Hi-Fi Products
Service Bulletin

CSA-13

Model: TC-WR901ES

Subject: No Operation With Remote Commander

[MAIN BOARD]

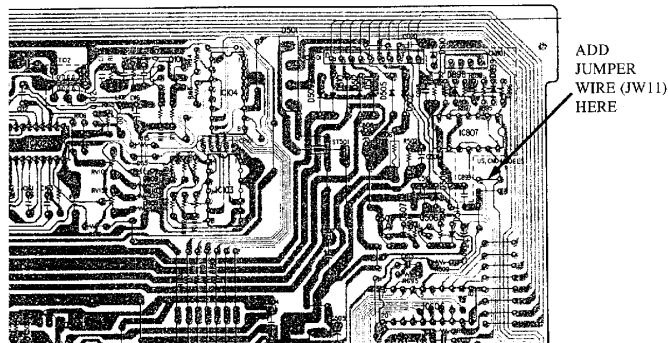
(25) The unit will not respond to IR Remote Commands.

Solution: Install missing jumper wire, JW11, onto the Main board as shown below.
